Access Compliance Report

Public Rights-of-Way

(Curb Ramps)

Intersection ID: 49801	Main Street: PARSIFAL_LN	Cross Street: GANDOLFO_CT	Location:	N
ADA ID: 1F705A6B78CC	Ramp Type: PerpDiag	Initial Pass/Fail: Fail	Overall Compliance: No	Severity Score: 46.25
Codes/Mitigation Info/Possible Solution		Field Measurements/Component Compliance

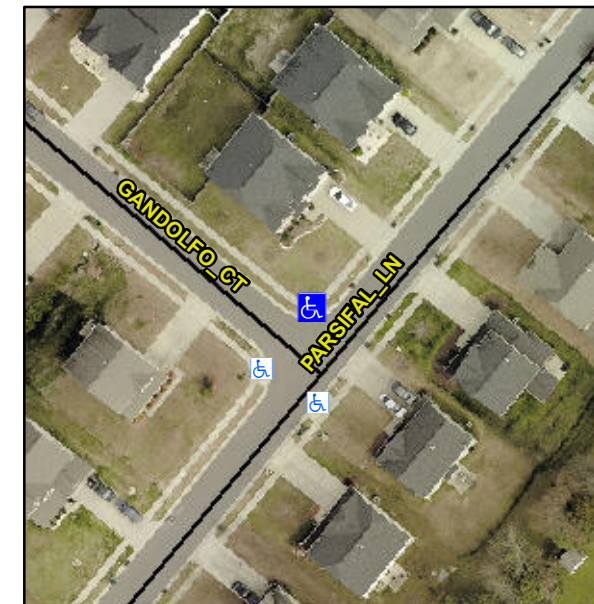
Not Found, R304.5.1, R304.2.2, R304.5.3

Compliance	Description	Data	Compliance	Description	Data
N/A	Ramp Length (in)	48.0	No	Ramp Slope (%)	12.6
No	Ramp Width (in)	47.0	No	Ramp XSlope (%)	5.1
N/A	Flare Type LT	N/A	N/A	Flare Type RT	N/A
N/A	Flare Slope LT (%)	N/A	N/A	Flare Slope RT (%)	N/A
N/A	Flare Traversable LT?	N/A	N/A	Flare Traversable RT?	N/A
N/A	Landing Length (in)	N/A	N/A	DWS Provided?	N/A
N/A	Landing Width (in)	N/A	N/A	DWS Contrast?	N/A
N/A	Landing Slope (%)	N/A	N/A	DWS Length (in)	N/A
N/A	Landing X Slope (%)	N/A	N/A	DWS Full Width?	N/A
N/A	Landing Curb? (Y/N)	N/A	N/A	DWS Offset (in)	N/A
N/A	Shared Landing?	N/A			
N/A	Gutter Ponding?	N/A	N/A	Gutter Slope (%)	N/A
N/A	Gutter Lip Ht (in)	N/A	N/A	Gutter X Slope (%)	N/A
N/A	Painted X Walk1?	No	N/A	Painted X Walk2?	No
	X Walk 1 Direction	To SW		X Walk 2 Direction	To SE
N/A	X Walk 1 Width (in)	N/A	N/A	X Walk 2 Width (in)	N/A
	X Walk 1 Slope (%)	3.2		X Walk 2 Slope (%)	N/A
	X Walk 1 X Slope (%)	4.2		X Walk 2 X Slope (%)	N/A

Remove & Replace Curb Ramp With Two New Directional Ramps or Equivalent.
